APPENDIX G

Comment Letters

AGENCIES AND INDIVIDUALS COMMENTING ON THE DRAFT EIS/EIR

Re: SCH#2011041008; Joint NEPA.CEQA Document; draft Environmental Impact Report and draft Environmental Impact Statement (DEIR/DEIS) for the "CASA DIABLO IV GEOTHERMAL DEVELOPMENT PROJECT;" located in the Town of Mammoth Lakes; Mono County, California

### Local Government Boundaries and Spheres of Influence (SOI) in Casa Diablo Geothermal Project Vicinity

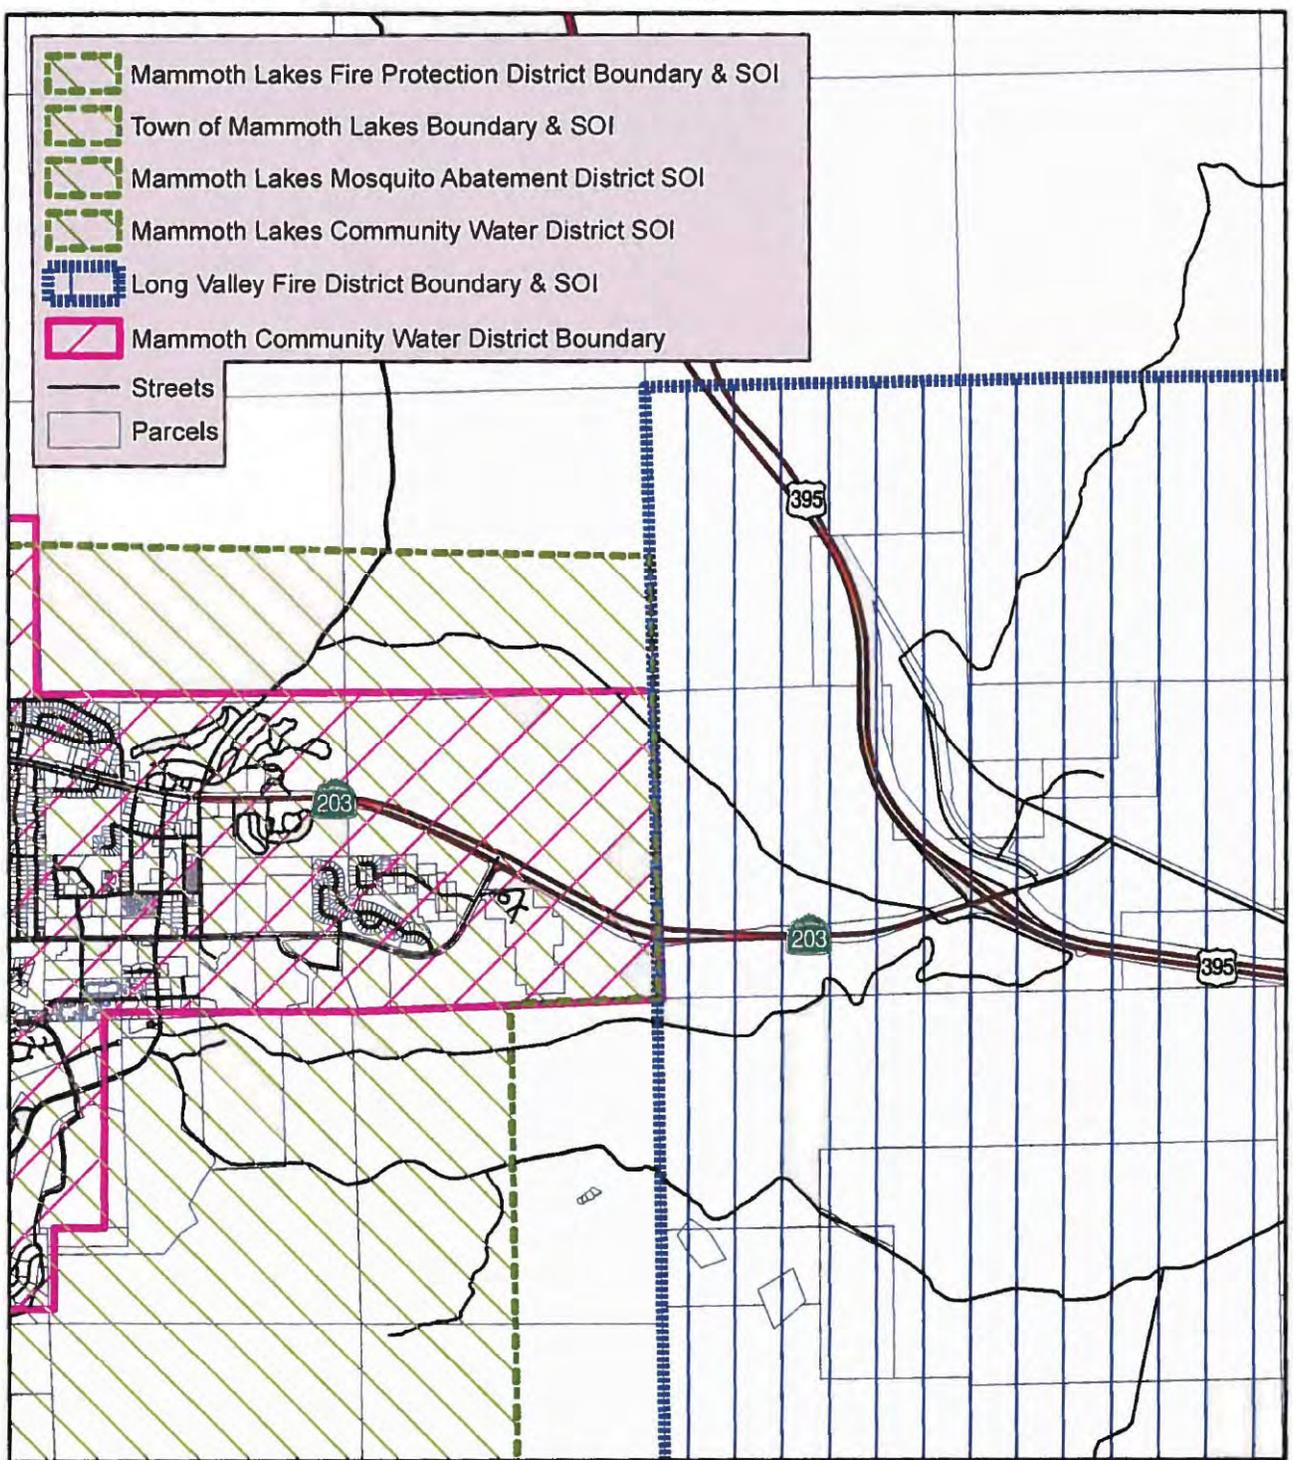
1. Several of the figures (aerial project layouts) show Town of Mammoth Lakes Municipal boundaries and private owned parcels. It is our recommendation that the Long Valley Fire Protection District boundary be shown on these figures as well. In particular Figure 3.10-1. Long Valley is capable and ready to continue to provide service inside its boundaries

A11-1 The comment provides a map by Mono LAFCO to clarify the fire districts and sphere of influence boundaries in the Project vicinity. Refer to Response A3-1 in which modifications to Figure 3.10-1 have been made.

Wetlands Figure 3 over DEIS/DEIR Figure 2-8

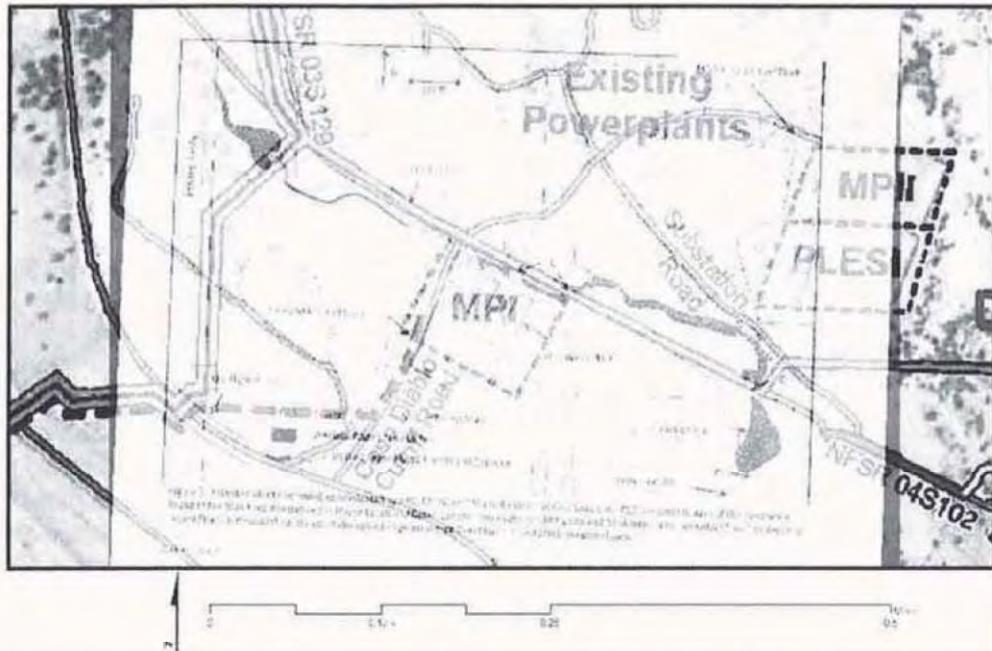
Figure 1. Project features near existing power plants in relation to wetlands mapped by Paulus. Project pipelines (turquoise lines) would pass through wetlands (dark blue polygons).

Wetlands Figure 4 over DEIS/DEIR Figure 2-8

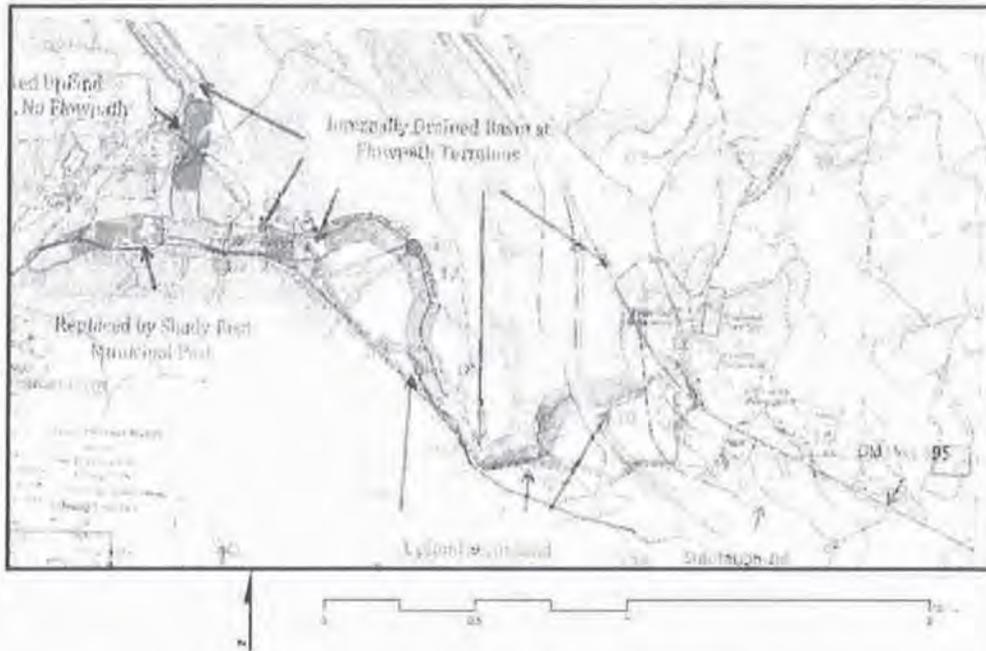
Figure 2. Project features in relation to RCAs (red corridor) and blue line streamcourses. Project pipelines (turquoise lines) would pass through RCAs and potentially jurisdictional features (non-shaded portions of corridor).

**Figure 3.3-2**  
Potential Wetlands and Waters of the U.S.

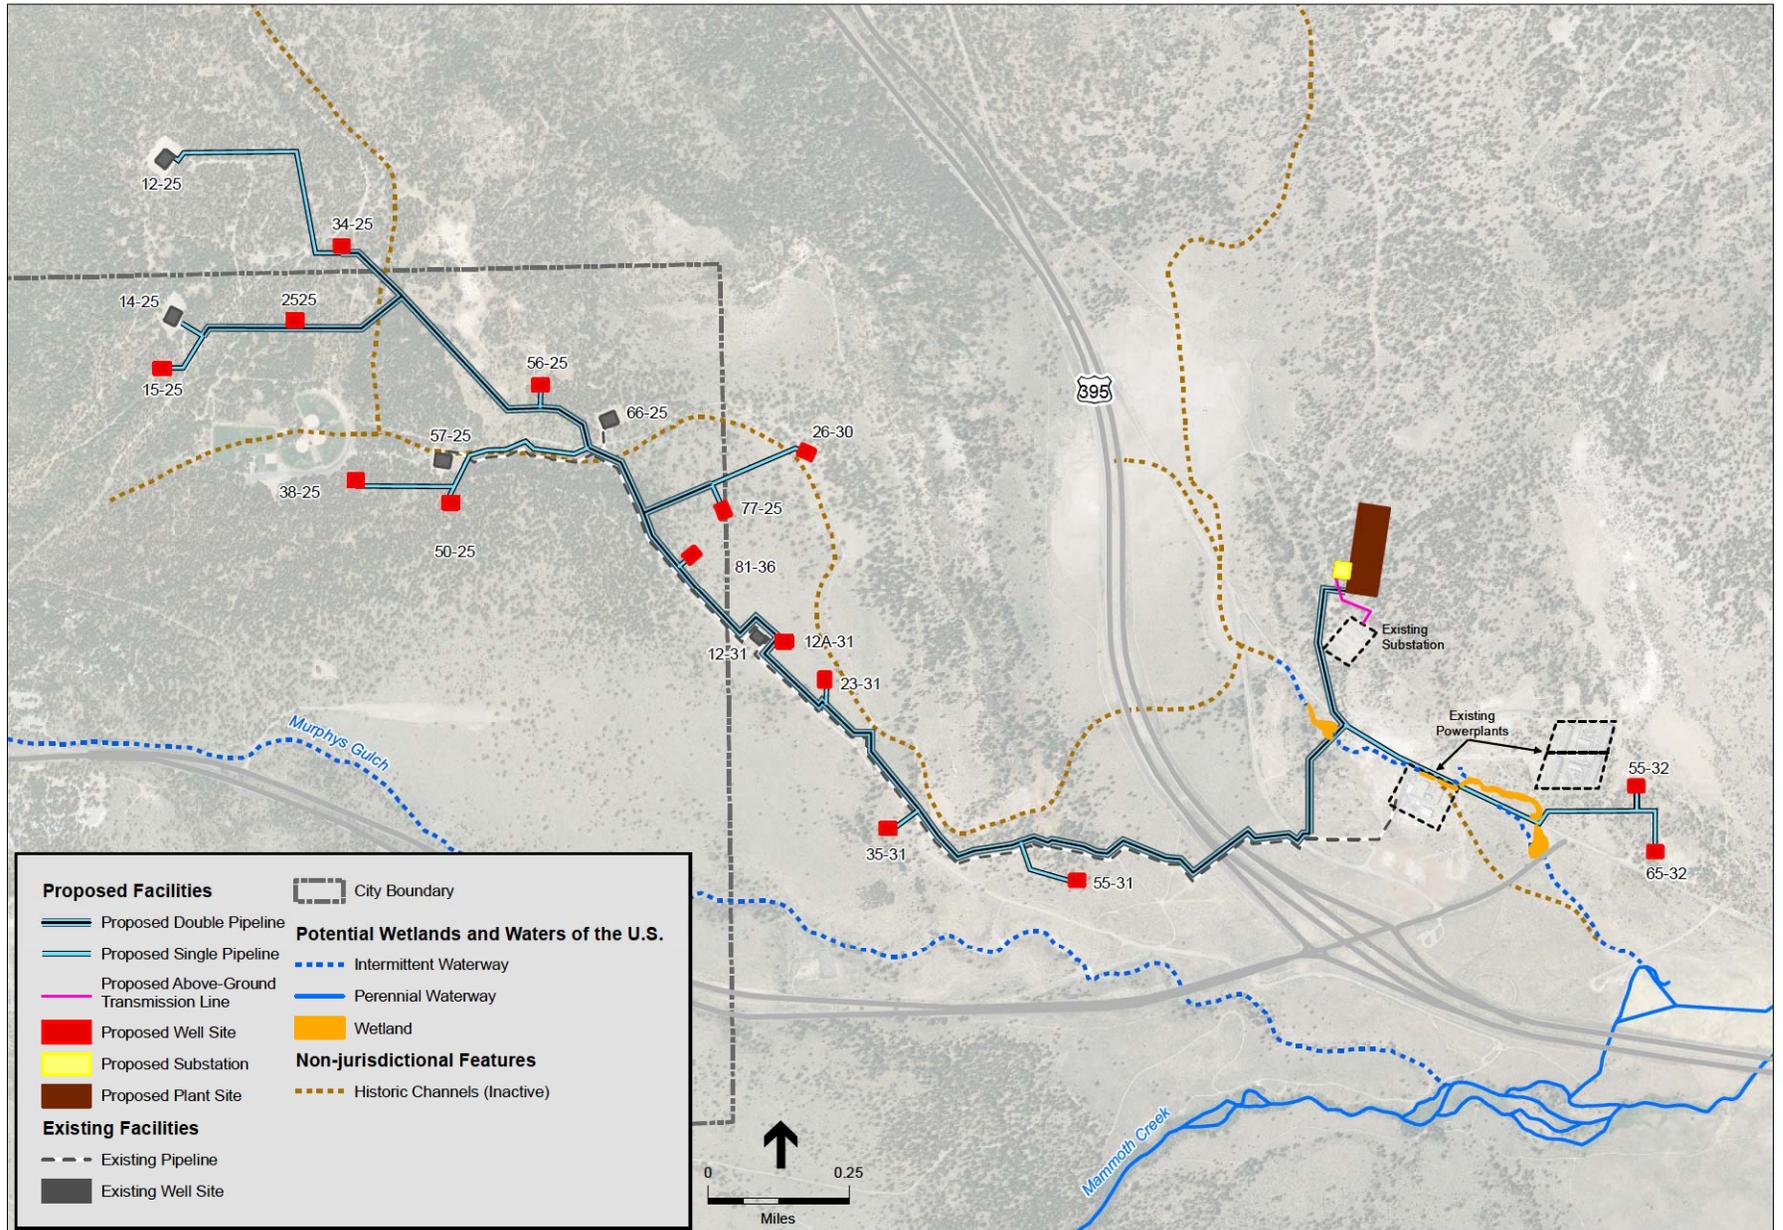
I used a geographic information system to overlay the map of Project features on the maps provided in Paulus’s wetland delineation report. The resulting maps do not support the statements that (a) Project facilities are not planned for areas that support vegetation typically associated with wetlands; and (b) pipelines and access roadways would be located outside of any delineated Riparian Conservation Areas (“RCAs”).<sup>95</sup> To the contrary, the maps depict new pipelines traversing through wetland plant communities, RCAs, and potentially jurisdictional wetlands (Figure 1 and 2).

Add new Figures (Figures 3.3-2 and 3.3-3).
